**APPLICATION FOR PERMISSION
UNDER SECTION 16 OF
THE TOWN PLANNING ORDINANCE
(CAP.131)**

**Proposed Temporary Shop and Services for a Period of 5 Years in "Residential (Group C)" Zone,
Lots 1377 RP and 1378 RP in D.D. 105, Ngau Tam Mei, Yuen Long**

Responses-to-Comments

(Application No. A/YL-NTM/438)

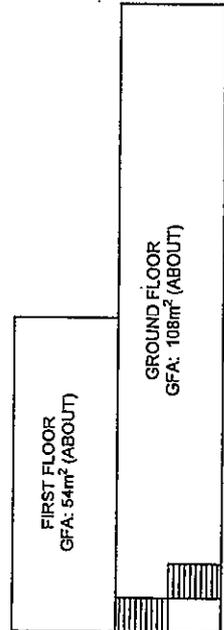
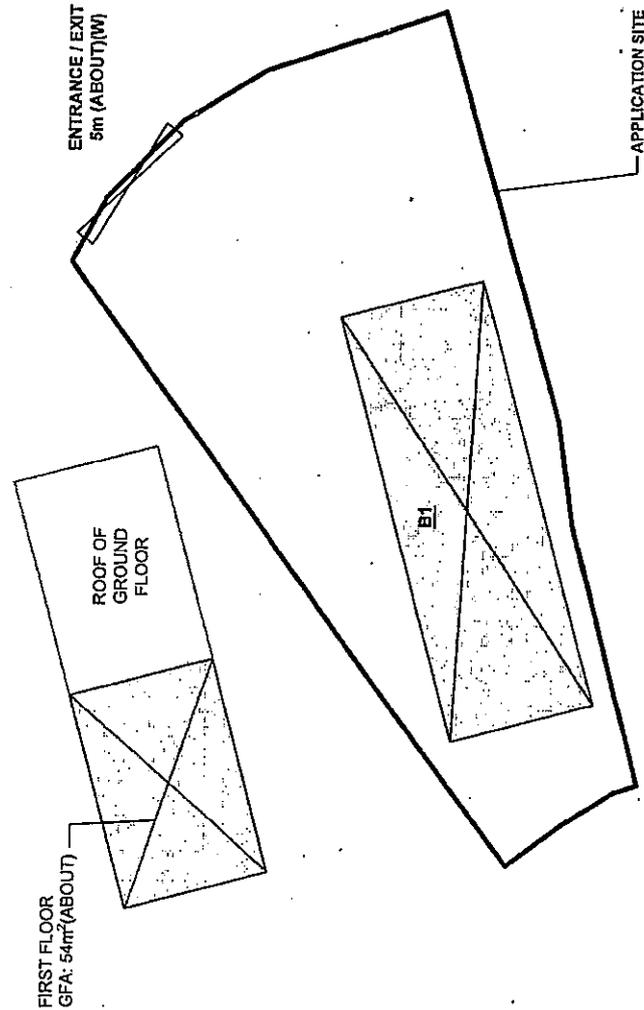
Departmental Comments		Applicant’s Responses
1. Comments of Commissioner for Transport (Contact Person: Mr. Kinox WONG; Tel: 2399 2727)		
(a)	The applicant should indicate the loading/unloading area off site.	The Applicant seeks to use the application site (the Site) to operate a ‘shop and services’ (convenience store) to serve the nearby locals. Regarding the loading/unloading (L/UL) arrangement, only one 5.5 tonnes lorry will be deployed for delivery of goods once a day between 10:00am to 11:00am for approximately 10 minutes. No vehicle will enter the Site and the L/UL activities will be carried out at San Tam Road on the basis that it will not affect traffic flow. Same arrangements have already been adopted by the approved S.16 planning applications (Nos. A/NE-LYT/723, A/NE-KTS/498, A/YL-MP/314 etc.) with no loading/unloading provision and are workable.

- (a) he has no objection in principle to the proposal subject to fire service installations being provided to the satisfaction of the D of FS.
- (b) in consideration of the design/nature of the proposal, FSIs are anticipated to be required. Therefore, the applicant is advised to submit relevant layout plans incorporated with the proposed FSIs to this Department for approval. In addition, the applicant should also be advised on the following points:
 - (i) the layout plans should be drawn to scale and depicted with dimensions and nature of occupancy; and
 - (ii) the location of where the proposed FSI to be installed should be clearly marked on the layout plans.
- (c) advisory comments as detailed in **Appendix IV**.

(b)	No vehicle is allowed to access the Site during the planning approval period.	Noted. The Applicant will ensure no vehicle will access the Site at any time during the planning approval period.
